ADDENDUM

SUBJECT: Amendment No. 5-98-307 A1 (Griswold), Item No. Th 11a, Scheduled for Hearing on Thursday, August 7, 2008 in Oceanside, CA.

Ref: CDP Amendment 5-98-307-A1 Griswold
29 Bay Drive, Laguna Beach

- Subject: GRADING AND DRAINAGE PLAN REVIEW
Proposed Single-Family Residence
29 Bay Drive
Three Arch Bay
Laguna Beach, California

Approved Bluff Stabilization Project 5-97-371
Cross Section at 25 Bay Drive
(adjacent to subject site 29 Bay Drive)
25 Bay Drive Approved Pad Elevation = 48 feet
29 Bay Drive Approved Pad Elevation = 53 feet

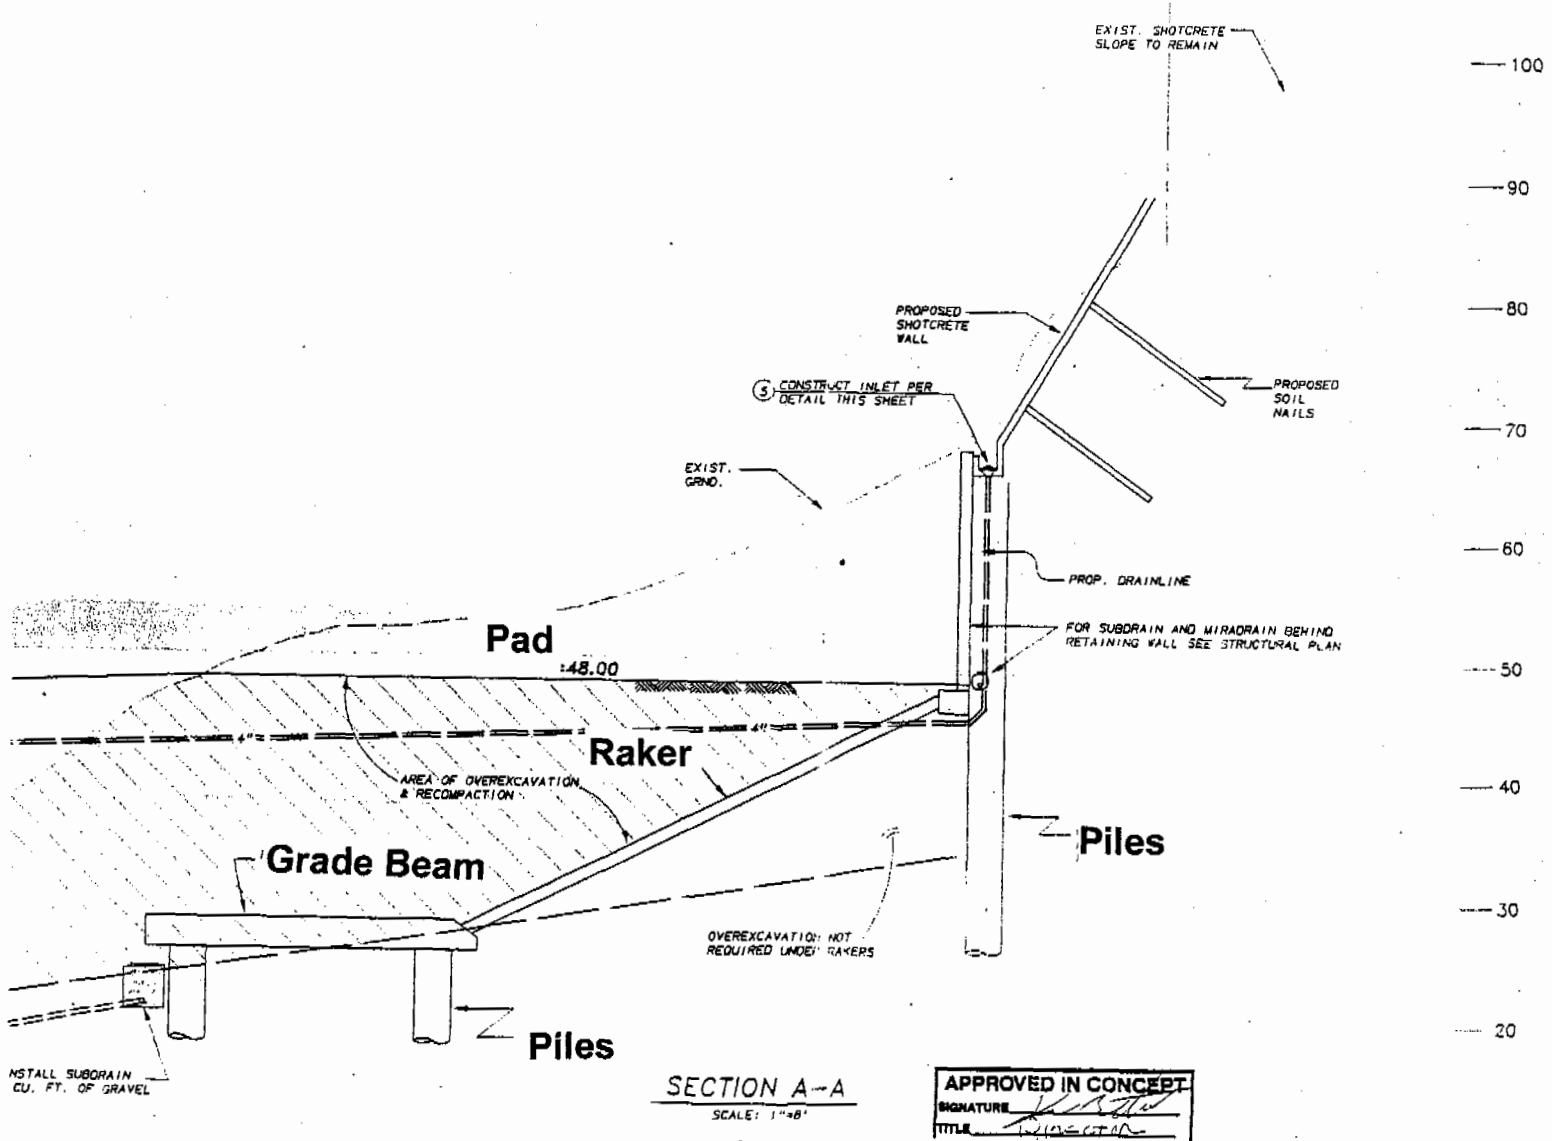
1. The first letter objects to the amendment based on claims that the amendment's request to lower the grading pad will adversely affect the stability of the site and surrounding area, and specifically that the additional grading will adversely affect the previously approved landslide stabilization project that exists across four lots, including the subject site.

The letter states: *"We believe that any consultant would agree that removing any quantity of compacted soil at the base of a stabilization wall decreases the existing factor of safety."*

The letter also disputes the amount of grading that would be necessary to accomplish the proposed lower pad elevation. The amendment request indicates that 120 cubic yards of cut material will be required to achieve a pad elevation that is 1 ½ feet lower than the proposed pad elevation (from 55 ½ feet to 53 feet). The letter states that in order to lower the pad by 2 ½ feet, a total of 191 cubic yards of cut material would need to be removed.

Finally, the letter indicates that additional independent geotechnical review should be required as a condition of approval of this amendment, as was required in approving the bluff stabilization project (5-97-371, Conrad).

In response to the concern regarding adverse affects on bluff stabilization, the proposed pad elevation of 53 feet is still higher than the pad elevation of the three other lots included in the stabilization project. Those lots range in elevation from 47 feet to 51 feet. Moreover, the bluff stabilization work extends well below the revised pad elevation of 53 feet. The bluff stabilization project was approved as a shoring wall system using concrete rakers, grade beams, and deadman piles (see attached approved stabilization plan). The bluff stabilization shoring system was approved as a single, uniform project across four lots. The piles were approved "to be founded ten feet (10') into bedrock

below the projected failure plane (clay seam).” The grade beam shown on the approved plan is located approximately at elevation 25 feet and is connected to the deadman pile shoring wall by a raker. The grade beam is supported by concrete deadman piles. The pad elevation proposed in the amendment (53 feet elevation) is well above (28 feet above) the elevation depth of the grade beam and significantly well above the depth of the deadman piles of both the grade beam and the shoring wall. The adjacent homes were successfully constructed on pads at elevations lower than the proposed amendment pad elevation. Thus, staff believes that the concern raised in the letter of objection that the proposed lower pad elevation will result in destabilizing the site and surrounding area is not borne out by the facts.

5-98-307A1
 PROPOSED PLANS

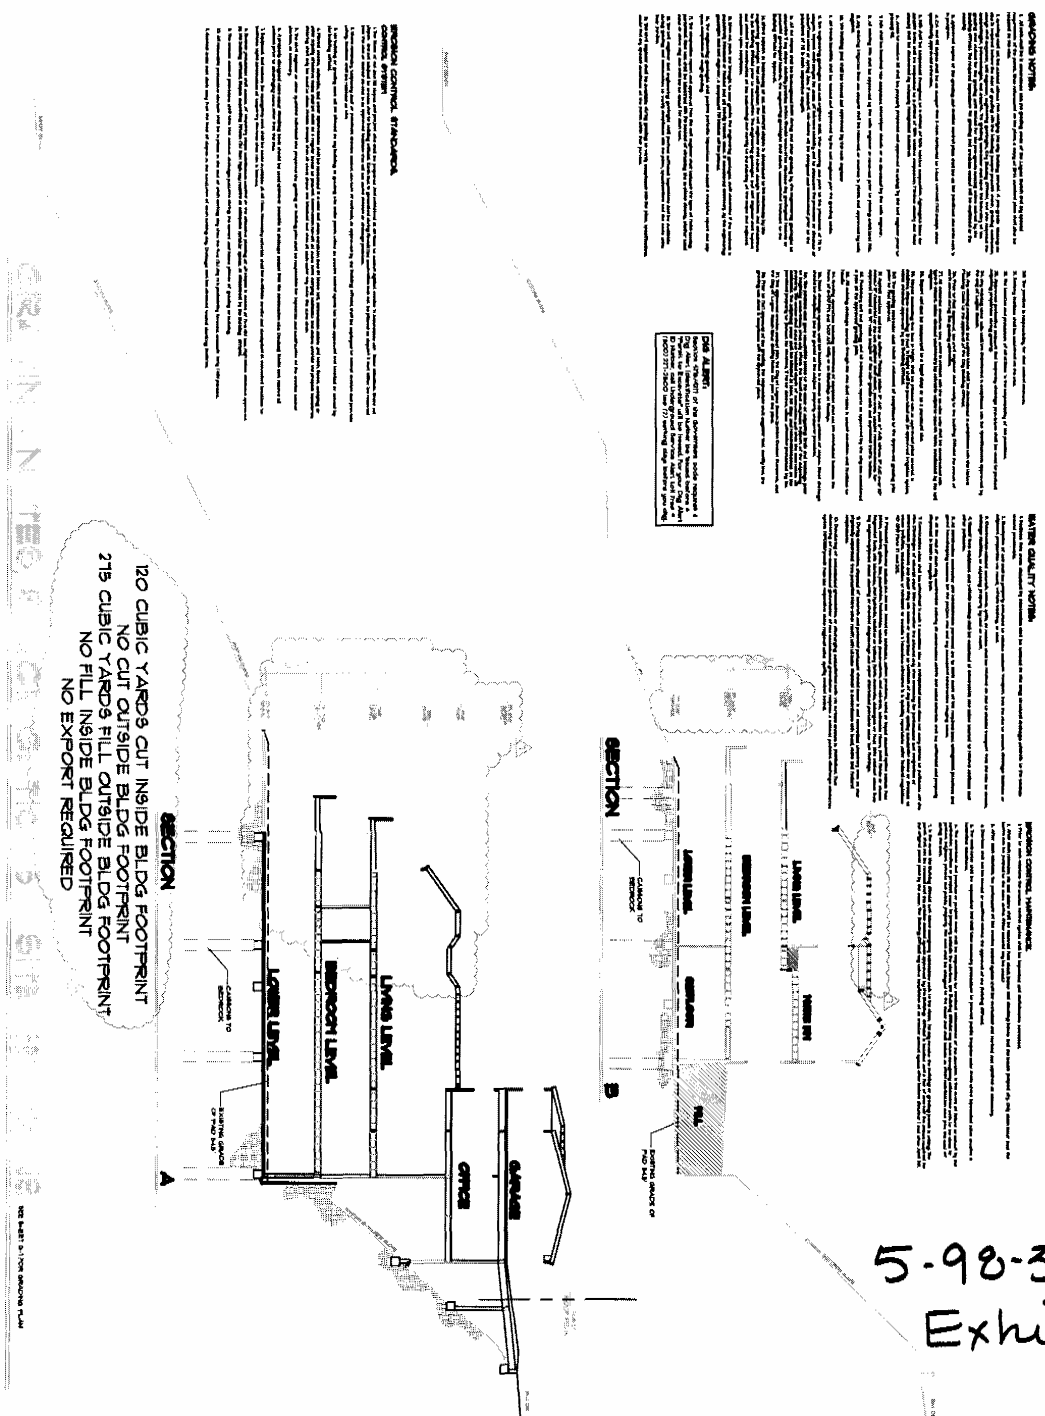
The amended plans show removal of 120 Cubic Yards of compacted soil from the upper building pad at the base, or toe, of the drilled pier and shotcrete wall which stabilizes the road and homes across the street. **This clearly reduces the design factor of safety and can contribute to geological instability.**

Please note that the plans are not accurate. In lowering the finished floor there will be a removal of almost 200 Cubic Yards of compacted soil compared to the original approval:

$(\text{Elevation Change} = 55.5 - 53 = 2.5') \times (\text{Bldg. Footprint} = 2067\text{SF}) = 5168\text{Cu.Ft.} / 27 = 191\text{Cu.Yds.}$

With regard to whether the pad will be lowered by 1 ½ feet or 2 ½ feet is addressed in the staff report as follows:

With the subject amendment request, the applicants propose to modify the previously approved project by lowering the elevation of the building footprint pad by approximately 1 ½ feet, which in turn will lower the finished floor elevation of the residence from 55 ½ feet to 53 feet. To accomplish this, additional grading is proposed: cut material is proposed to be increased by 120 cubic yards.

The applicant’s representative has furthered explained the 1 ½ feet versus 2 ½ feet change in pad elevation as follows:

“He is claiming that the description of the modification is inaccurate because the pad is shown to be lowered only 1.5 feet when the building is being lowered 2.5 feet. The description is actually accurate. When the landslide stabilization was completed, the pad was left lower than it would need to be so we would have a place to put the dirt from the caissons when they were drilled. The existing pad elevation will need to be lowered 1.5 feet from its current elevation.”

The letter questions whether the amount of grading (120 cubic yards) necessary to accomplish the lowering of the pad grade is accurate, if the lowered pad is actually 2 ½ feet lower, rather than the 1 ½ feet indicated in the project description. Based on the discussion above, it appears that 1 ½ feet is the correct figure for the change in pad elevation. However, even if the correct figure is 2 ½ feet and the amount of excavated material is greater (191 cubic yards), it would not affect the underlying bluff stabilization structure, as that structure is still well below the revised pad elevation. Therefore, staff continues to recommend approval of the proposed amendment as reflected in the staff report.
